# HISTORIC DISTRICT COMMISSION

## CERTIFICATE OF APPROPRIATENESS

**Application Number:** HDC2025-00511

**Project Address:** 19545 shrewsbury rd. Detroit, MI

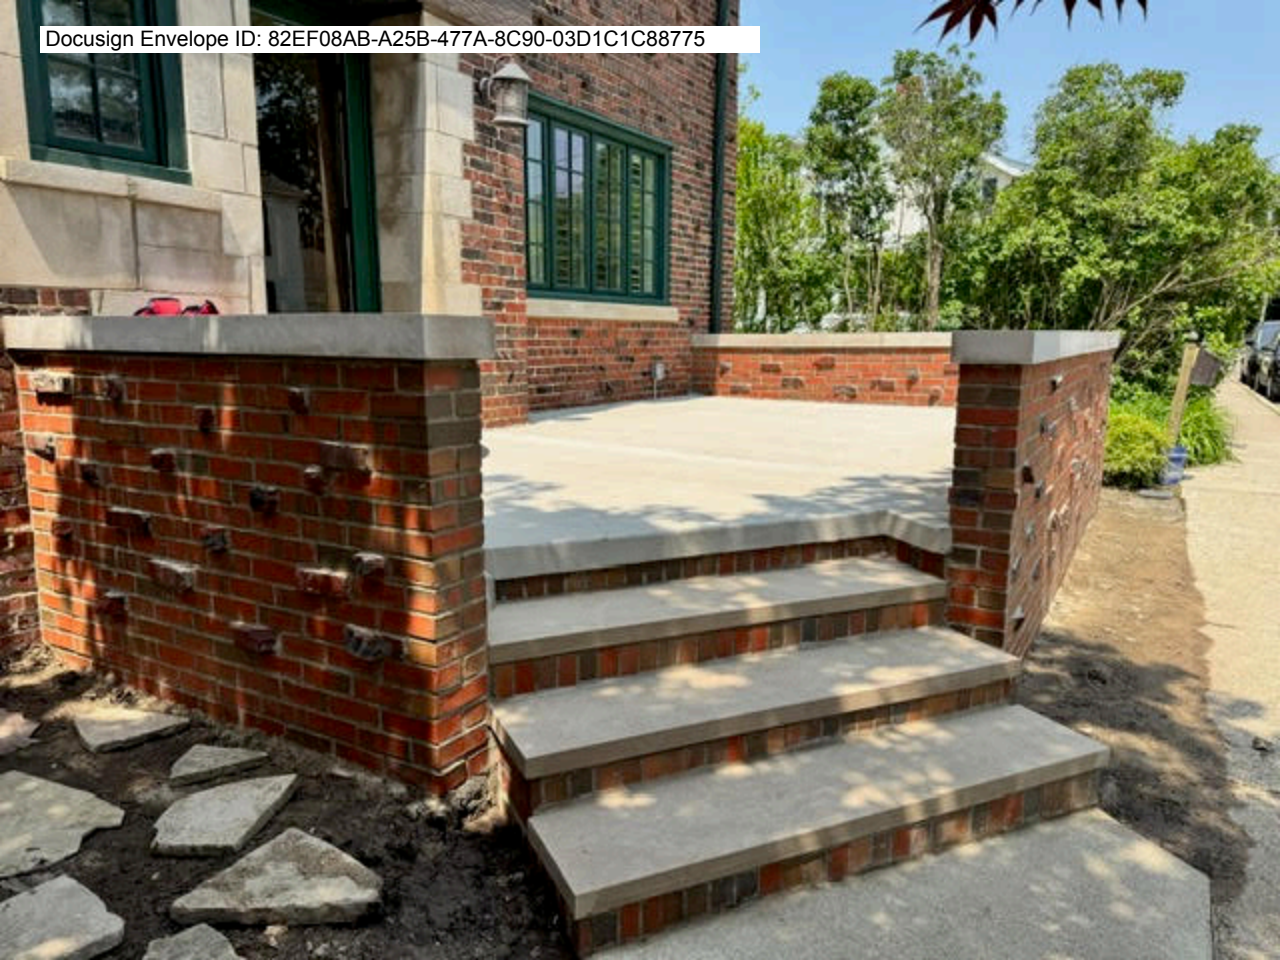
Please provide more information about the re-rod along wall of home. If construction drawings have been prepared for the building permit application, please share them. (If the drawings have not yet been prepared, a clear written description should be sufficient.) Please provide more information and some photos of the window well that will be parged.

Regarding the parging, apologies, I should have included more information around that. The window well currently has approx. 1" thick layer of mortar covering the brick however it has started to break apart. Madison Maintenance would repair the damaged pieces to ensure the integrity of the window well. I have included pictures of the window well. Note: It's a little hard to show the whole area with the porch grate and limited window access below.
